Bullet Tools recently redesigned our aluminum rail system. After considerable field-testing and listening to customer feedback, we have decided to upgrade the fasteners in the assembly of some machines to a longer version to prevent the rail from detaching from the head in certain circumstances. Included are the upgrade replacement screws for the head-end of the rails. (See Fig. 1). These must be installed on all affected machines.

Fig. 1

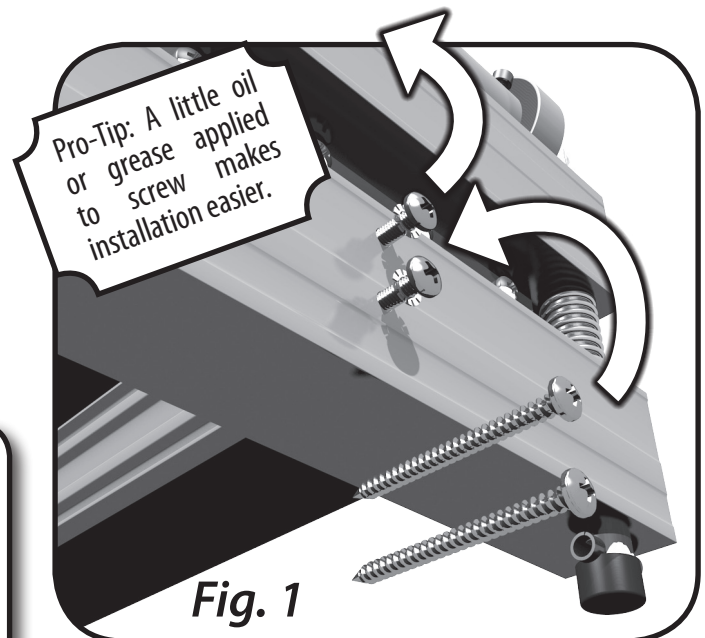
Machines Impacted	Solution
ES009	Replace (2) screws in assembled machine (See Fig. 1 & Fig. 2)
113FLR	Replace (4) screws in assembled machine (See Fig. 1 & Fig. 2)
213SID	Replace (4) screws in assembled machine (See Fig. 1 & Fig. 2)

- 1 Remove rail attachment screws.
- 2 Using included drillbit (17/64" or 'F'), enlarge screw holes in base. Do NOT drill rail!
- 3 Install new screws, with a small dab of grease (Included) on end of screw.
